## CONNECTICUT SITING COUNCIL

### **Petition No. 1415 Greenskies Clean Energy LLC North Stonington, Connecticut Draft Staff Report October 2, 2020**

RE: PETITION NO. 1415 - Greenskies Clean Energy, LLC petition for a declaratory ruling for the proposed construction, maintenance and operation of a 5.0-megawatt-AC solar photovoltaic electric generating facility on approximately 27 acres located generally northeast of the intersection of Boom Bridge Road and Anthony Road and south of Interstate 95 in North Stonington, Connecticut.

### Proposed Site Plan

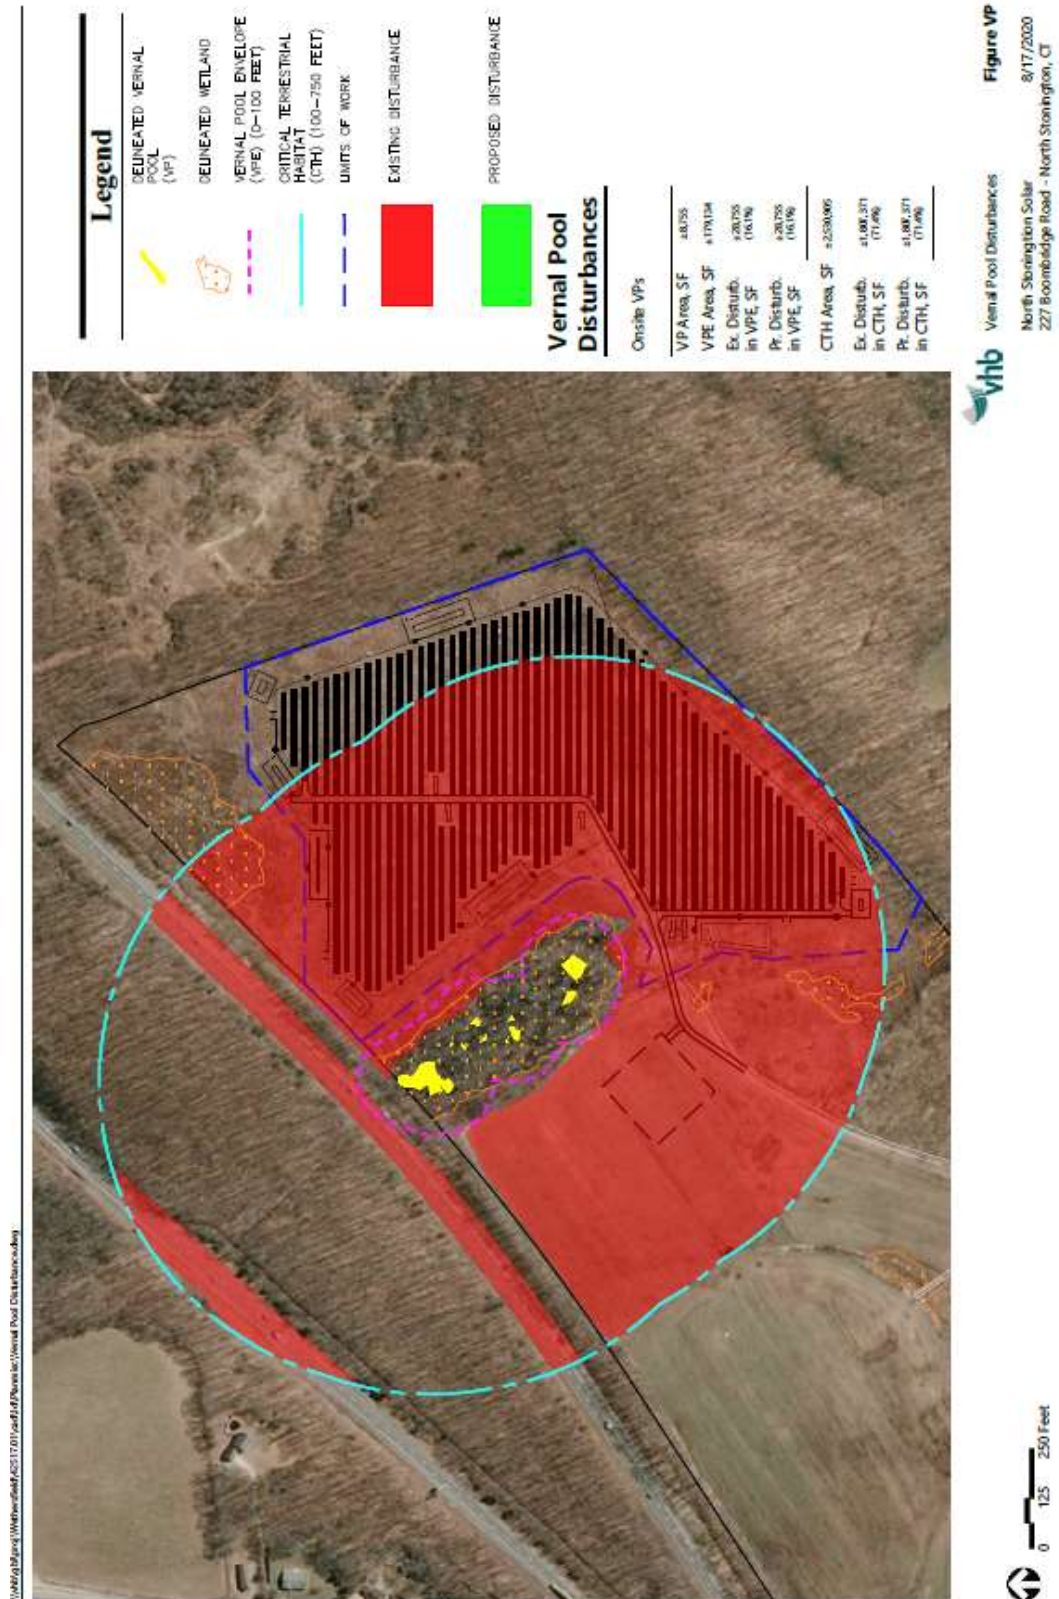
The Council notes that the contractor parking/staging area is partially located within the 100 foot wetland buffer, even though there appears to be considerable area to the northwest and west for that use. The Council recommends that the Petitioner consider relocating the contractor parking/staging area to be outside of the 100 foot buffer area. In addition, the Council recommends consideration of a rerouting of the proposed access road, which is proposed to traverse the center of wetland #4, to a more northerly route to take it out of the wetlands and make it closer to the contractor parking/staging area.

The proposed contractor parking/staging area located southwest of Wetland 1 was originally partially located within the 100-foot buffer of Wetland 1. However, the Petitioner will relocate such parking/staging area to ensure a wetland buffer of not less than 100 feet.
